SERVICE BULLETIN

AIR - BEARING COMPARTMENT COOLING HPC AIR BLEED TUBES - ADDITIONAL CLIPPING FOR CORE
TUBES - SERVO AIR TO HANDLING BLEED SOLENOID VALVES - CATEGORY CODE 4 -
MOD.ENG-75-0049

V2500-ENG-75-0049

Schematic view of bearing compartment cooling and HPC air bleed tubes showing clipping point arrangement before alteration

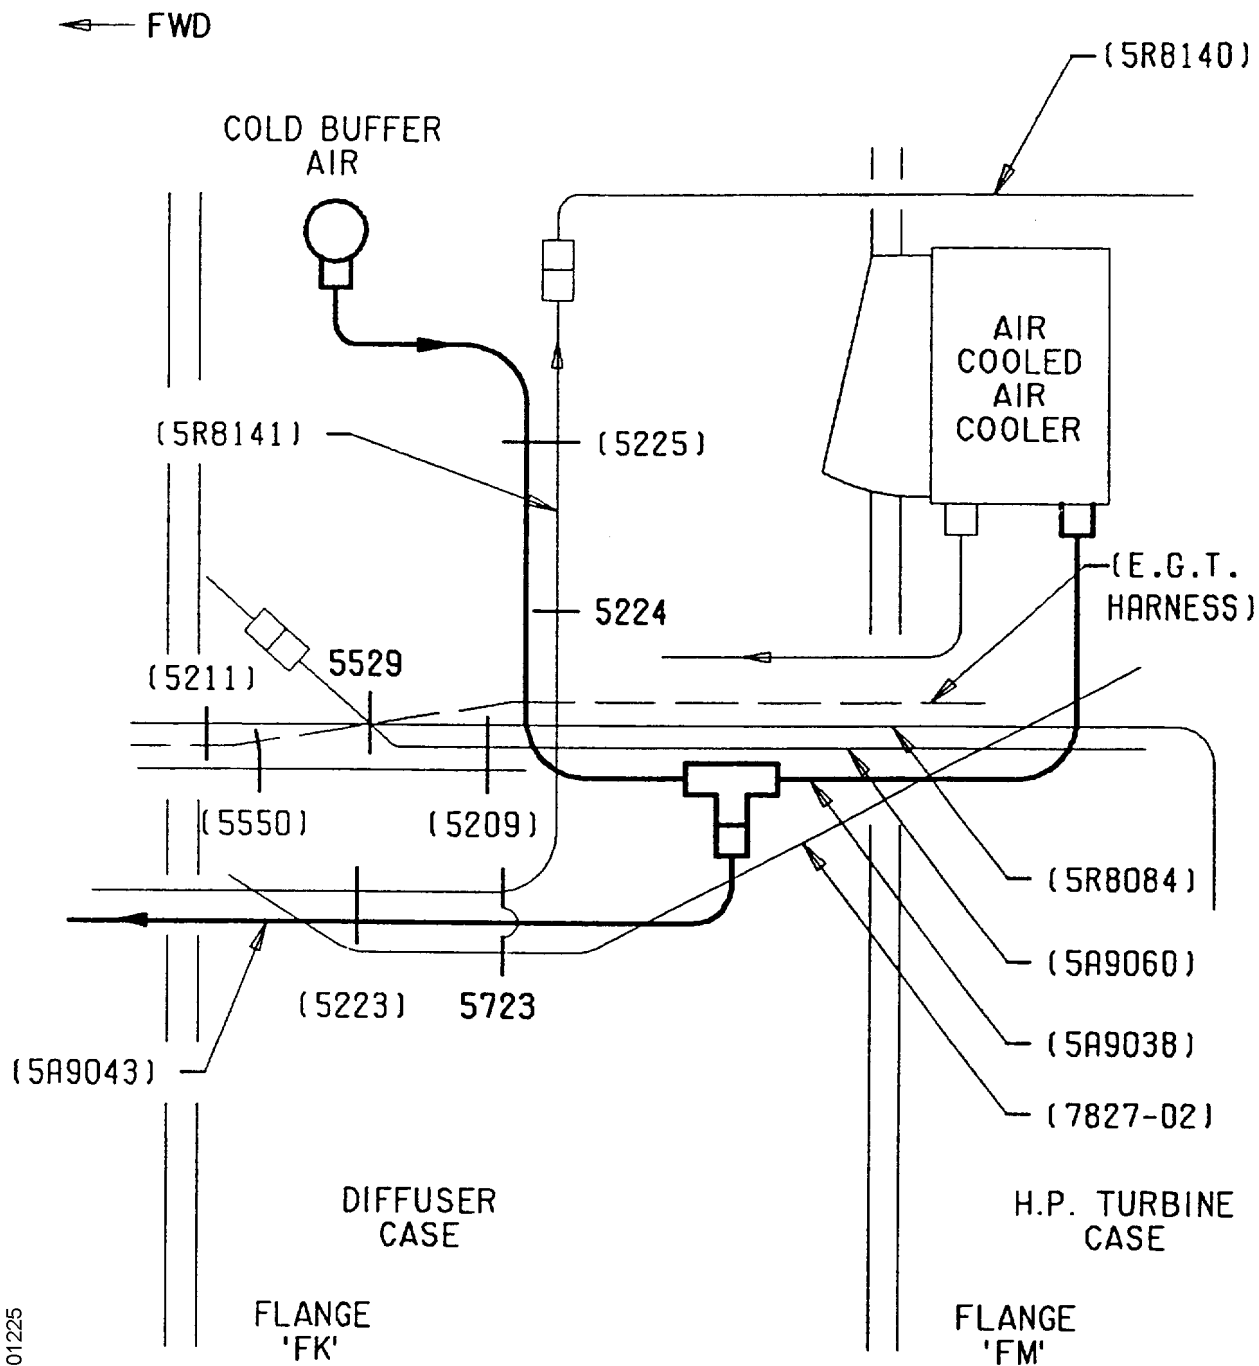
- (1) Find clipping points 5224 and 5529. Refer to figures 1 and 2.
- (2) Disassemble clipping point 5224, remove 4W0102 bolt, 5W1086 washer, 5R8141 tube and the 4W0043 clipnut from the 5W8360 bracket. Refer to figure 4.
- (3) Cut lockwire and remove the MS9573-13 bolts (2 off) and remove 5W8360 bracket from the No.11 fuel spray nozzle.
- (4) Disassemble clipping point 5529, remove the 4W0001 nut, 5W1086 washer, 4W0104 bolt and the 5W1086 washer. Refer to figure 5.

Schematic view of bearing compartment cooling and HPC air bleed tubes showing clipping point arrangement after alteration

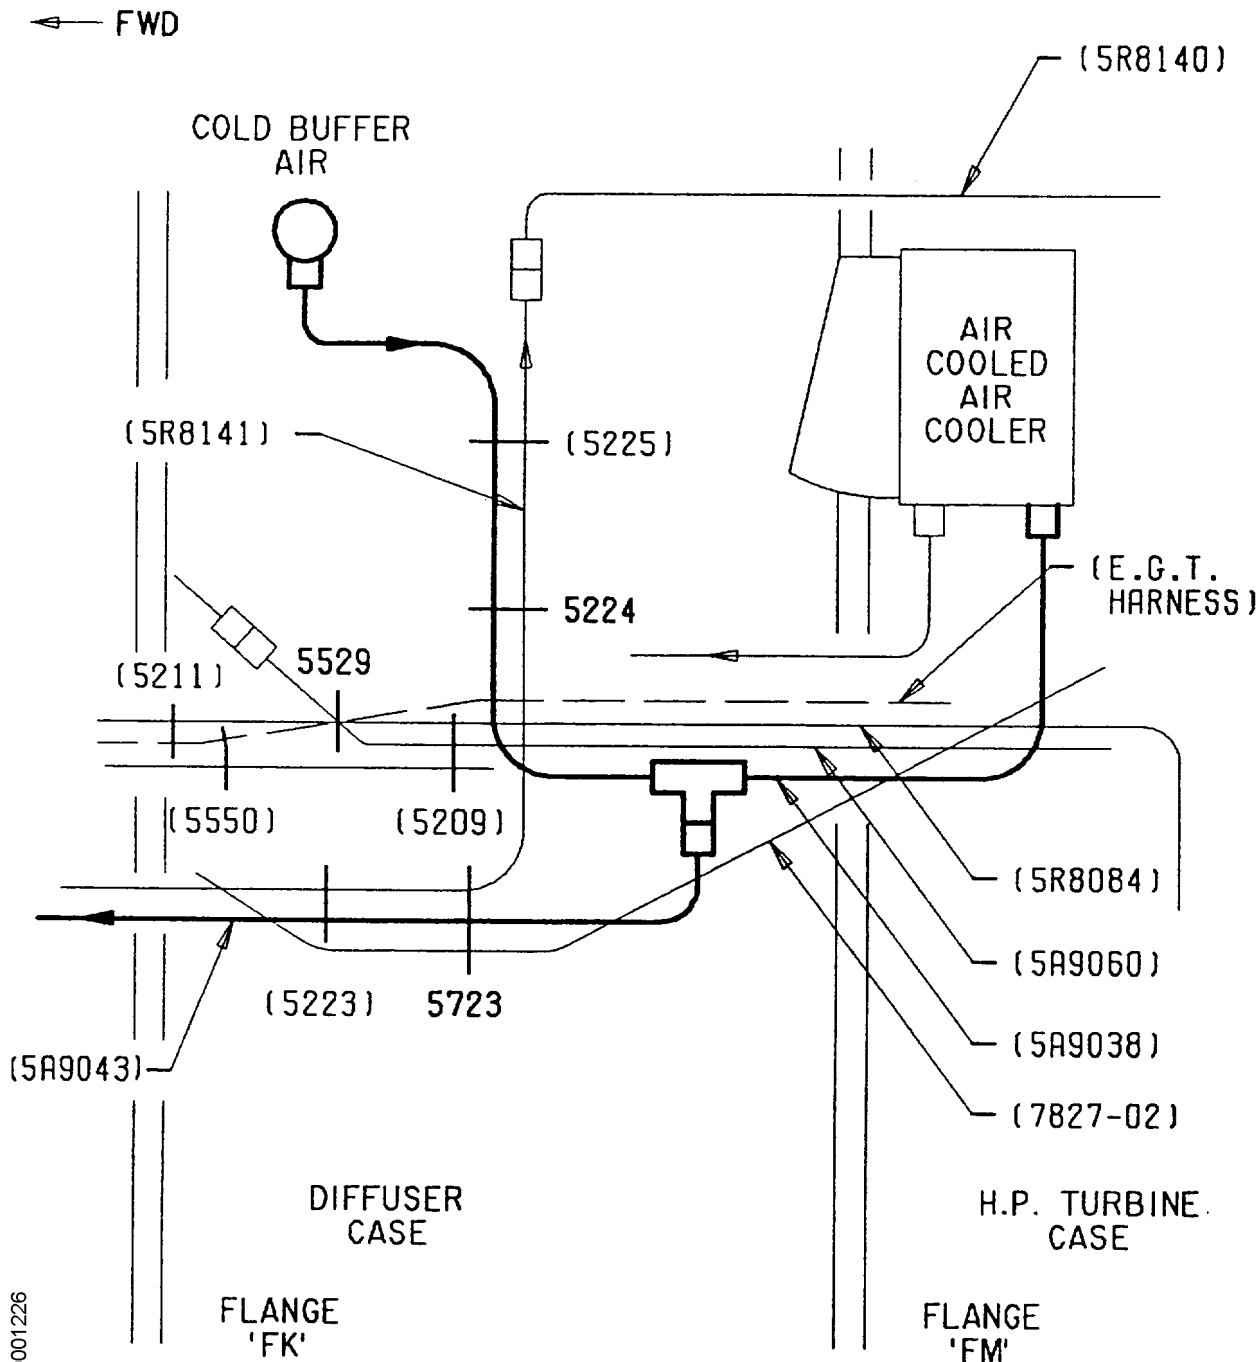
- (1) The air supply tube to the A.C.A.C. (5A9038) is now clipped with the No.5 bearing oil scavenge tube at CP5224. A re-designed bracket is required at the No.11 fuel spray nozzle to suit the modified clipping arrangement.
- (2) Service Bulletin V2500-NAC-26-0004 deletes CP5723 hardware from EBU.
- (3) The air supply tube to the solenoid valves (5A9043) is now clipped at CP5723 along with the core fire detection rail.
- (4) To provide adequate clearance with CP5723, the EGT harness clip at CP5529 is rotated 180 deg. and supported on a spacer.

- (1) Install the new 6A5555 bracket to the No.11 fuel spray nozzle using MS9573-13 bolts (2 off). Torque the bolts to 65 to 85 lbfin (7,3 to 9,6 Nm). Safety the bolts with V02-141 lockwire, as instructed in the A320 Aircraft Maintenance Manual, TASK 70-40-11-911-012. Refer to figures 3 and 4.
- (2) Re-assemble existing clipping point 5224. Install new TA0210046FT12 clip to 5A9038 tube. Install new 4W0116 bolt to 5R8141 tube clip, 6A5555 bracket, LK56556 spacer, TA0210046FT12 clip and the 4W0001 nut. Torque the nut to 36 to 45 lbfin (4 to 5 Nm). Refer to figures 3 and 4.
- (3) Re-assemble existing clipping point 5529. Remove harness clip, rotate and reinstall to harness. Install new 4W0114 bolt to harness clip, LK67295 spacer, 5R8040 tube, 5A9060 tube and the 4W0001 nut. Torque the nut to 36 to 45 lbfin (4 to 5 Nm). Refer to figures 3 and 5.

- (4) Re-assemble existing clipping point 5723. Install new TA0210046FT08 clip to 5A9043 tube. Install new 4W0127 bolt to TA0210046FT08 clip, LK67295 spacer, 5R8141 tube, LK56556 spacer, 7827-02 firerail and new 4W0001 nut. Torque the nut to 36 to 45 lbfin (4 to 5 Nm). Refer to figures 3 and 6.
